HISTORIC AND DESIGN REVIEW COMMISSION

September 20, 2017

HDRC CASE NO: 2017-478
ADDRESS: 205 OSTROM
LEGAL DESCRIPTION: NCB 6938 BLK LOT 1&2
ZONING: R-4 CD, H, RIO-1
CITY COUNCIL DIST.: 1
DISTRICT: River Road Historic District
APPLICANT: Tobias Stapleton
OWNER: Tobias Stapleton
TYPE OF WORK: Demolition with new construction of two residential structures and two accessory structures

SITE PLAN scale: 1/16" = 1' - 0"

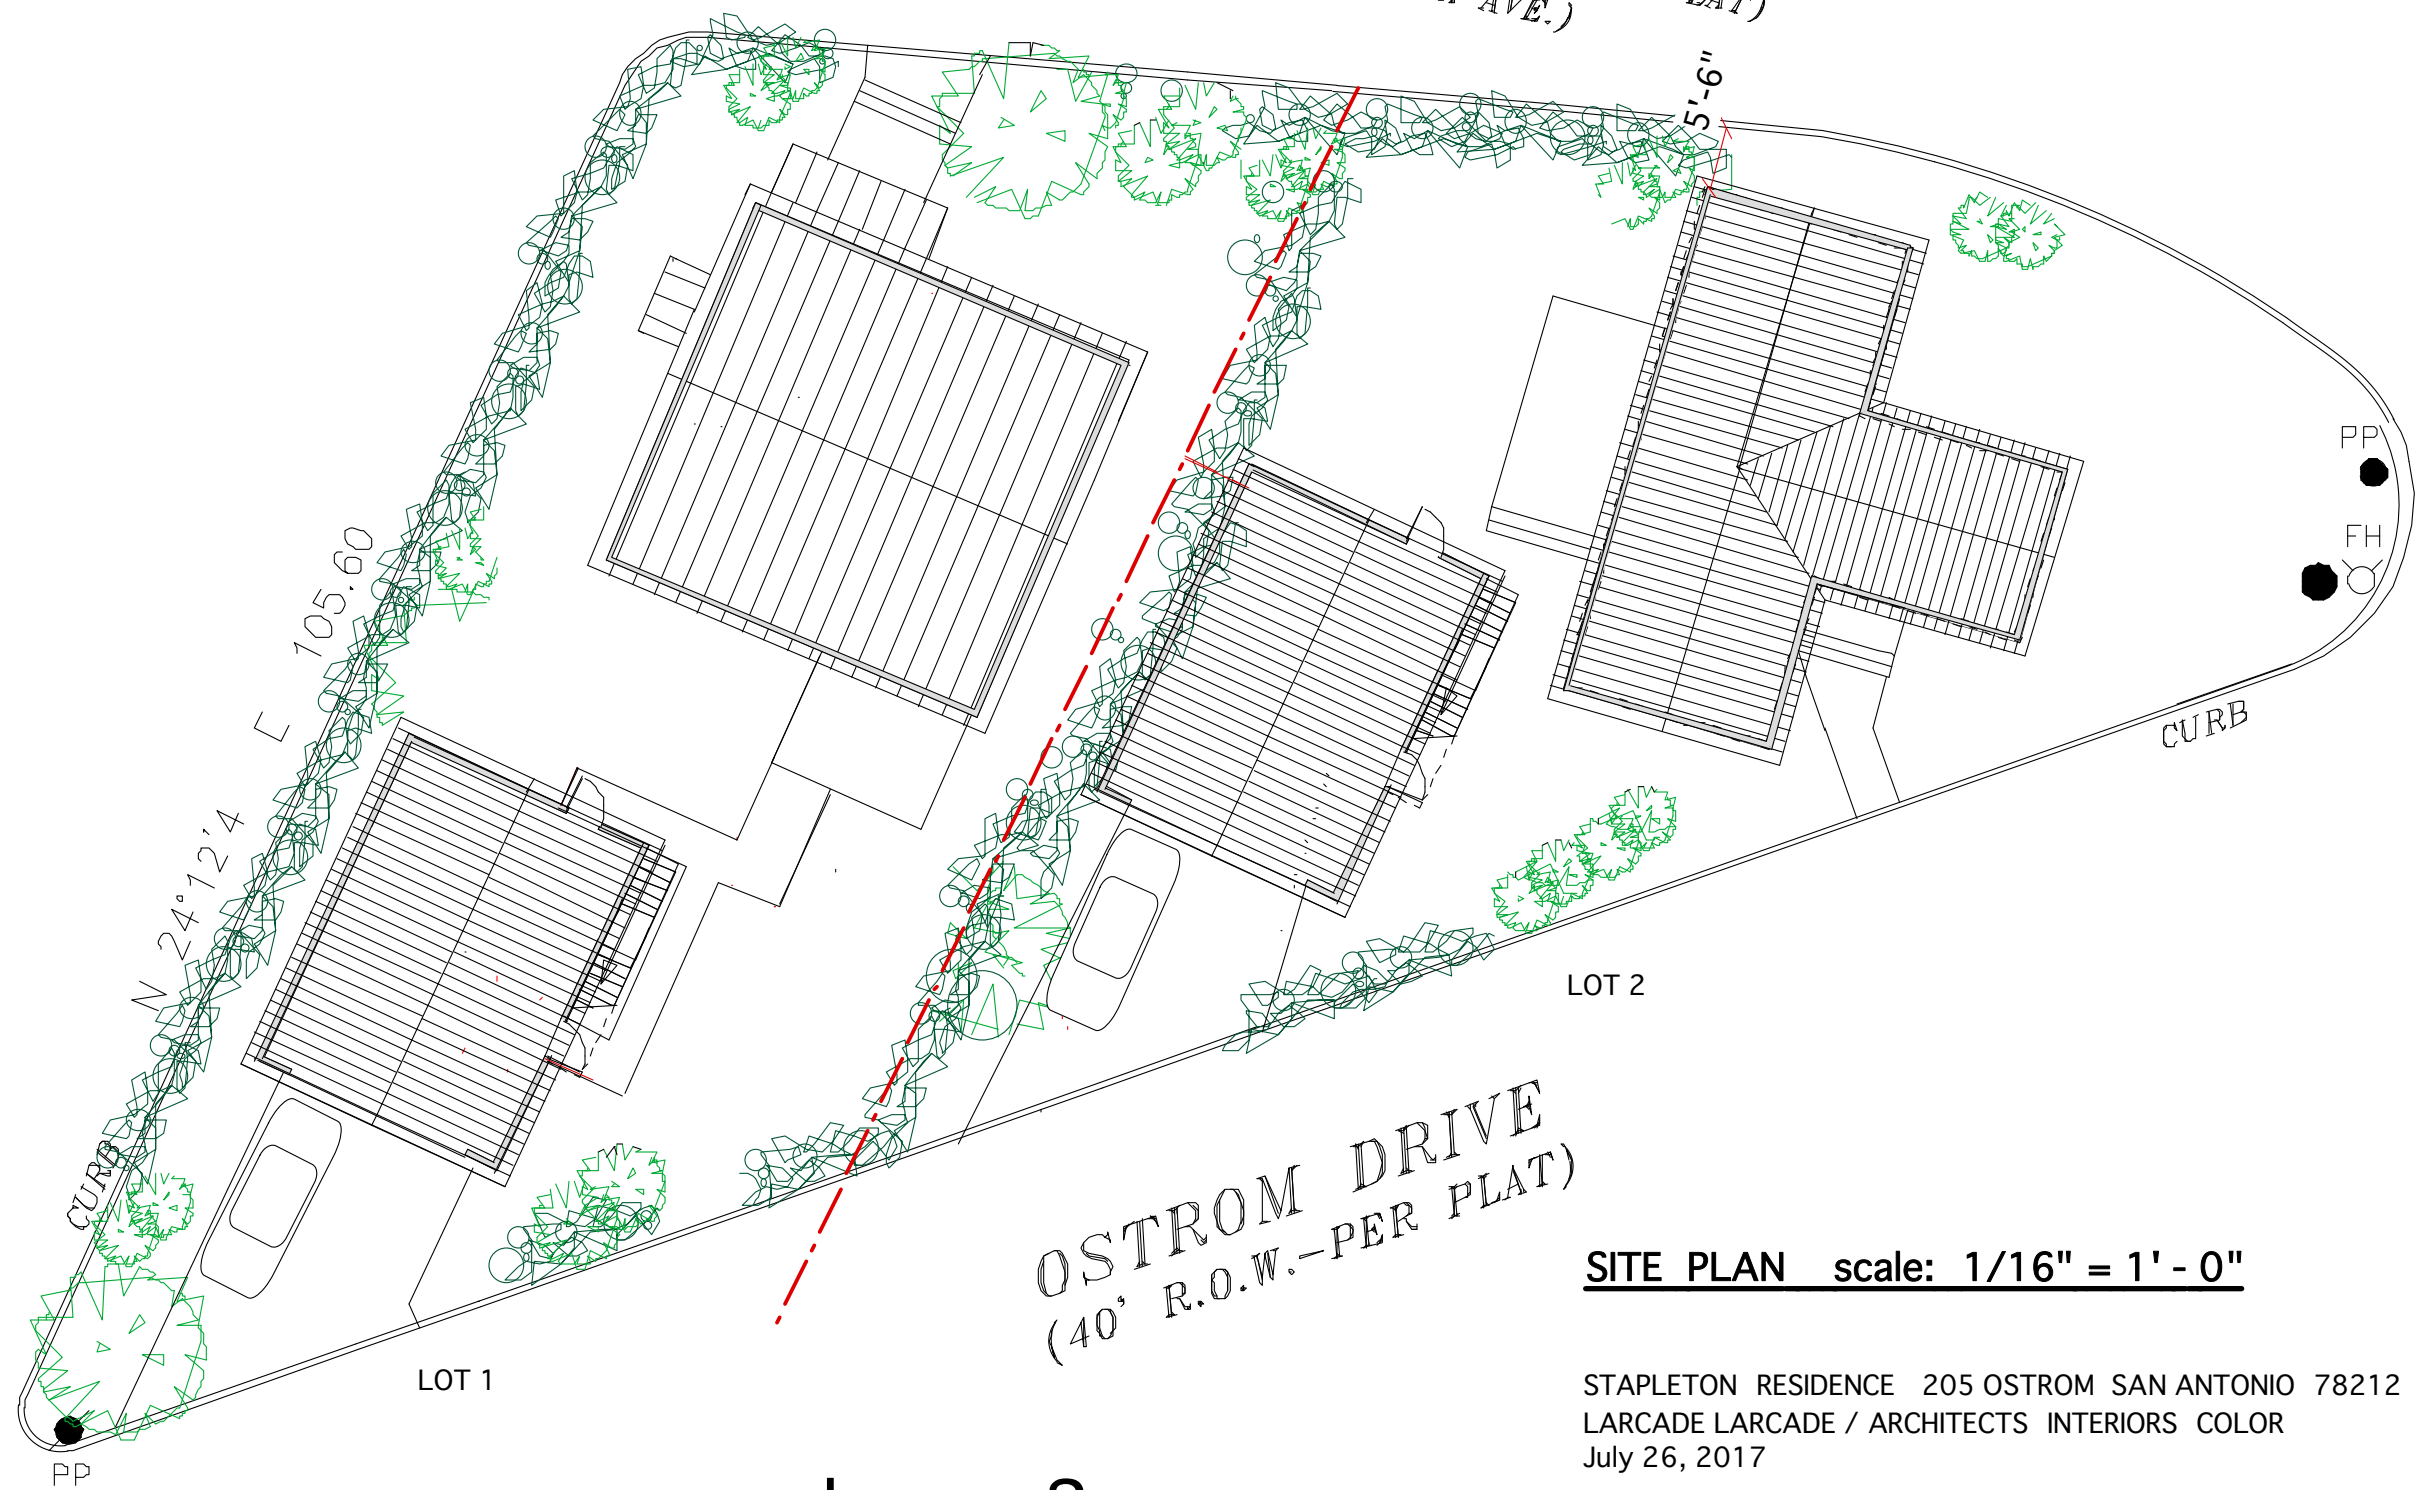
- 3a. SETBACKS & ORIENTATION – According to the Guidelines for New Construction, the front facades of new buildings are to align with front facades of adjacent buildings where a consistent setback has been established along the street frontage. Additionally, the orientation of new construction should be consistent with the historic example found on the block. The applicant has sited this structure in the middle of the lot. Generally, given the dimensions and shape of the existing lot, staff finds this arrangement appropriate.

- 5a. DRIVEWAYS – The applicant has proposed to introduce one new curb cut on the property to exist with an existing curb cut that is located on Ostrom Drive. The Guidelines for Site Elements note that historic profiles are to be used for the creation of curb cuts and that typical driveway widths are to be used, typically no wider than ten feet in historic districts; however, there are examples in the immediate area of curb cut and driveway widths that are wider than ten feet in width. Staff finds that the proposed driveway location are appropriate

Side Elevation House Lot 1 scale: 1/8" = 1' - 0"

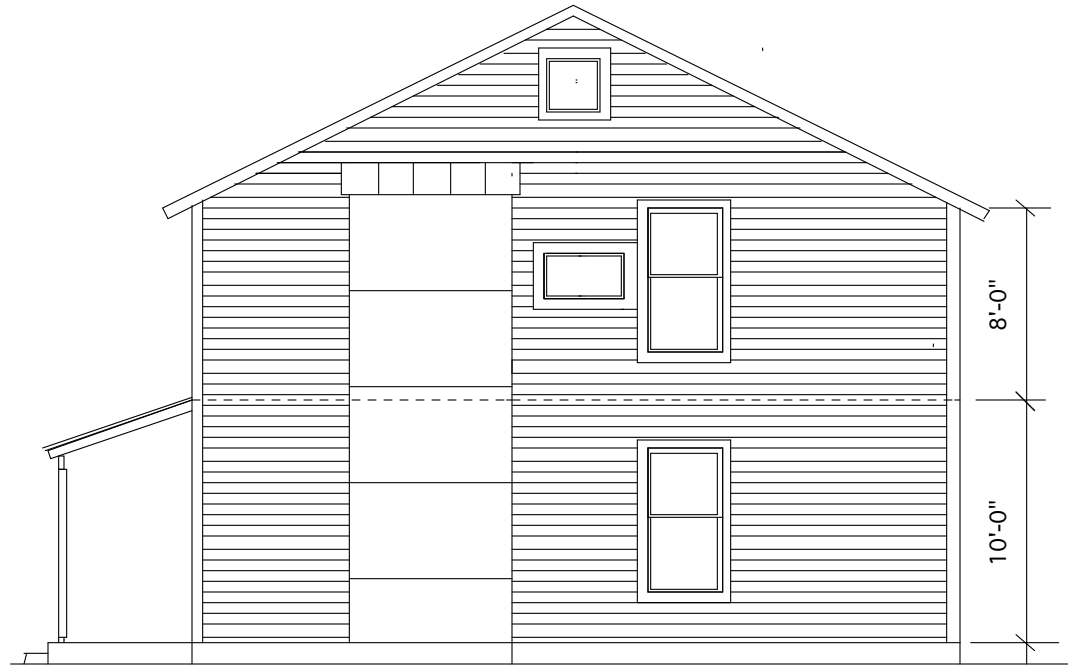
- 2e. ROOF FORM – The applicant has proposed roof forms that include both front and side gabled roofs. Each street, Ostrom, Magnolia Avenue and the intersection of the two will have a gable oriented towards them. Staff finds the proposed roof forms appropriate.

- 2h. MATERIALS – The applicant has noted the use of a standing seam metal roof and board and batten siding. Staff finds that the board and batten siding feature boards that are twelve (12) inches wide with battens that are 1 – ½” wide, that the standing seam metal roof feature panels that are 18 to 21 inches wide, seams are 1 to 2 inches in height, a crimped ridge seam or low profile ridge cap and a standard galvalume finish. A large profiled ridge cap shall not be used.

- i. That the applicant install board and batten siding feature boards that are twelve (12) inches wide with battens that are 1 – ½” wide, that the standing seam metal roof feature panels that are 18 to 21 inches wide, seams are 1 to 2 inches in height, a crimped ridge seam and a standard galvalume finish on the proposed structure in request item #2.

House Lot 2
South Elevation scale: 1/8" = 1'-0"

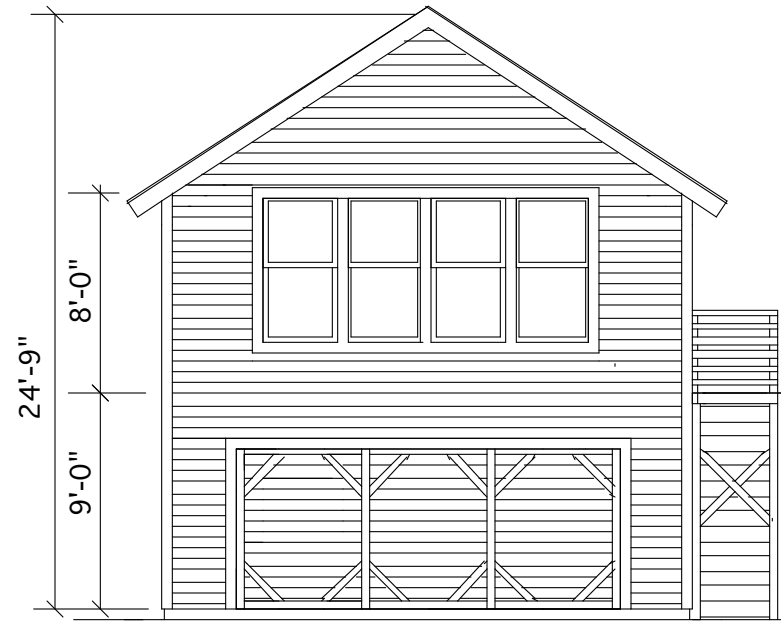
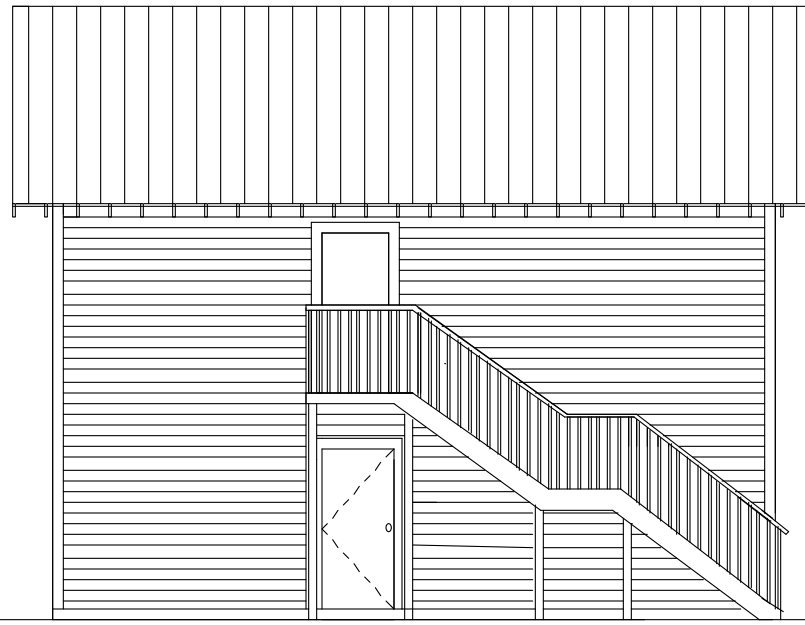
- 3e. ROOF FORM – The applicant has proposed to modify the previously proposed flat roof form to include a gabled roof, consistent with the Guidelines.

- 3h. MATERIALS – The applicant has noted the use of both vertical and horizontal siding; however, has not noted the material. Staff finds the use of wood or Hardi board siding to be appropriate; however, staff finds that the horizontally oriented Hardi siding should feature an exposure of four inches, that the board and batten siding feature boards that are twelve (12) inches wide with battens that are 1 – ½” wide.

- 3j. ARCHITECTURAL DETAILS – As previously noted, the applicant has proposed a flat roof in combination with horizontal and vertical siding. Typically, flat roofs that are found throughout the River Road Historic District feature Spanish Eclectic architectural detailing including decorative roof parapets. Staff does not find the proposed roof to be appropriate in relationship to the proposed materials and adjacent proposed structure. Staff finds that a second structure that matches the design of the structure in request item #2 would be more appropriate.

- iii. That the applicant should fully utilize architectural elements that are consistently found on structures with flat roofs throughout the district in a contemporary manner and incorporate materials that are appropriate for the proposed form for request item #3 as noted in findings 3e and 3j.

**Accessory Buildings
Identical one on each Lot
Qty 2**

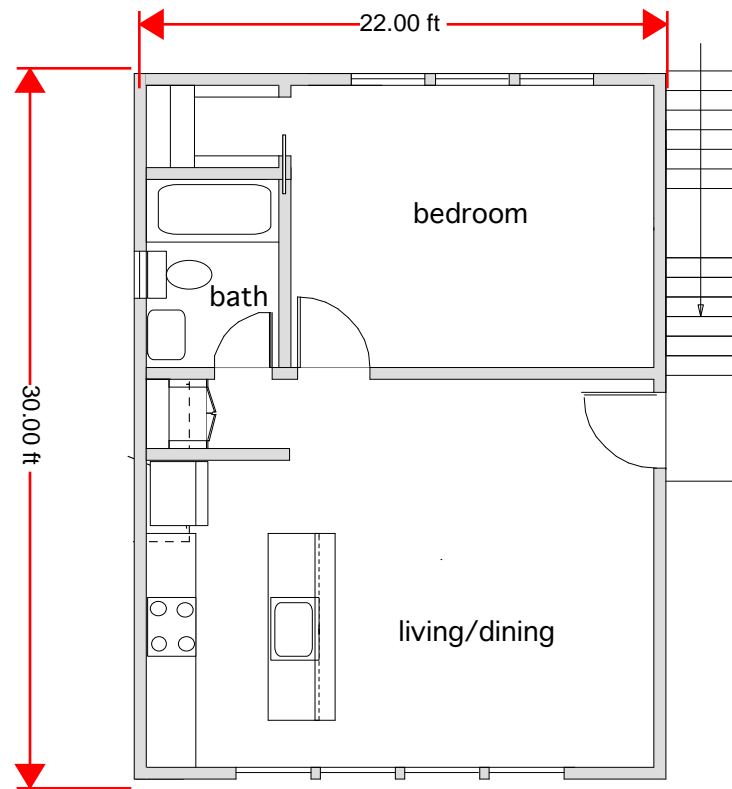
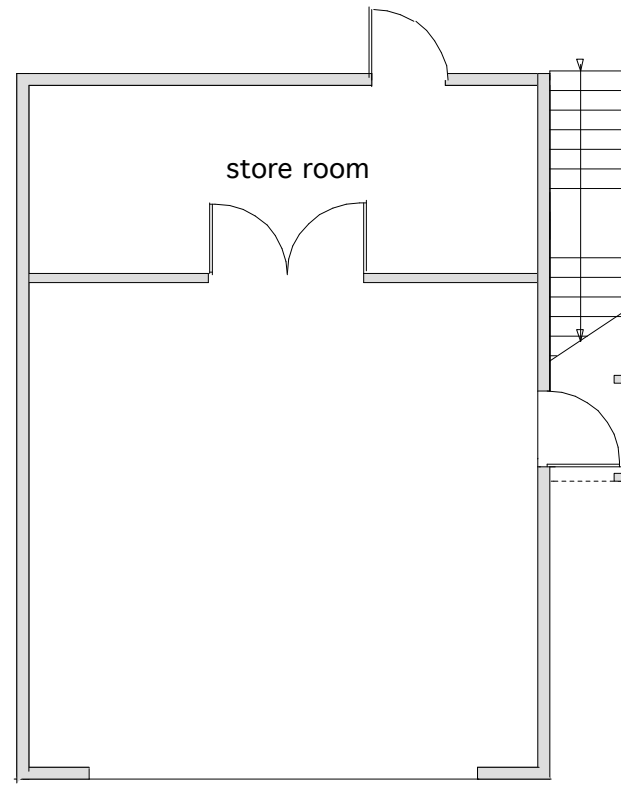
- 4a. ACCESSORY STRUCTURES – To the rear (west) of the structure noted in request item #2 and to the side (south) of the structure noted in request item #3, the applicant has proposed to construct two, two story accessory structures to accommodate vehicular parking as well as a second level dwelling unit. The proposed accessory structures feature an overall profile and massing that is subordinate to the proposed, primary residential structures, feature appropriately detailed garage doors and feature architectural detailing that’s consistent with the historic examples found throughout the River Road Historic District. Staff finds the proposed accessory structures appropriate and consistent with the Guidelines.

- iv. That the applicant propose a design for the accessory structure that is consistent with the Guidelines for New Construction as noted in finding 4a.
